Porsche Carrera Cup France 2022

Note Technique 19/2022

CENTREUR DE CREMAILLERE

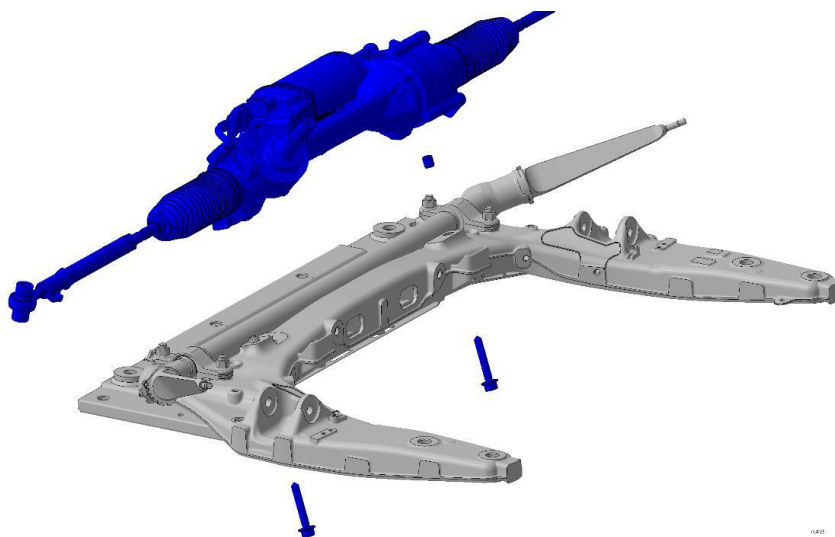
Porsche Motorsport vous informe qu'un nouveau centreur est désormais disponible pour fixer la crémaillère de votre Porsche 911 GT3 Cup (992). Toutes les pièces en question vous seront fournies gratuitement par l'organisateur de votre championnat. Pour les voitures non inscrites à une coupe de marque officielle Porsche AG, ces pièces peuvent être commandées gratuitement auprès de gt3cup.support@porsche.de en fournissant votre numéro de châssis.

- 1/ Démonter la crémaillère du berceau AV et retirer le centreur fendu, côté droit du véhicule.
- 2/ Positionner le nouveau centreur (plein) dans son emplacement sur le berceau, aussi loin que possible, en utilisant une vis + rondelle + écrou.
- 3/ Assembler la crémaillère sur le berceau (Loctite 243 + 30 N.m + angle de 90°)

Ref	Désignation	Qté par voiture
N 108.516.01	Centreur (fendu)	1
9F1.422.824	Centreur (plein)	1

BUSHING STEERING GEAR

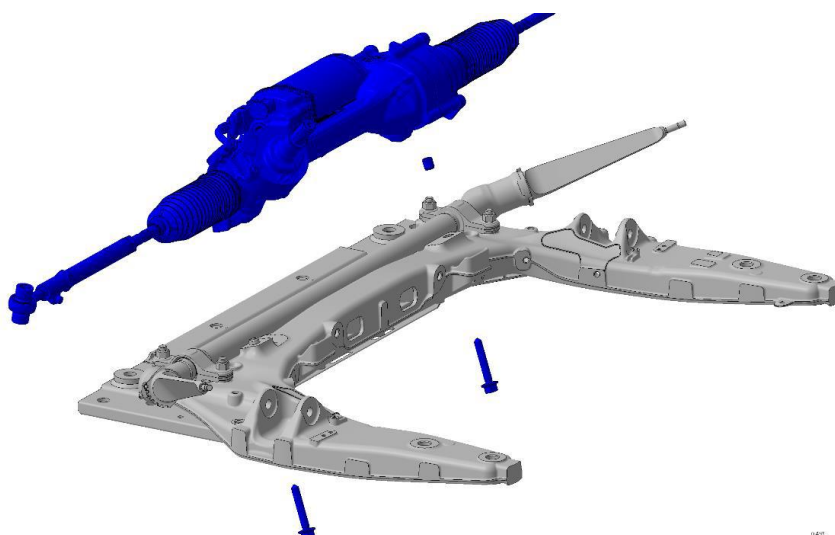
Porsche Motorsport informs that new bushes are available for fastening the steering gear to the Porsche 911 GT3 Cup (992). All necessary parts will be distributed free of charge by your local series organization. For cars not participating in a one-make championship, parts can be requested and ordered free of charge at gt3cup.support@porsche.de by stating the chassis number of the car.

- 1) Dismount the steering gear from the crossmember and remove the slotted bushing on the right-hand side of the car
- 2) Pull the new, unslotted bushing into the crossmember as far as it will go by using a screw, washer and nut
- 3) Mount the steering gear to the crossmember (30 Nm + 90° rotation angle + Loctite 243)

Part number	Description	Quantity per car
N 108.516.01	Roll pin	1
9F1.422.824	Sleeve steering gear	1
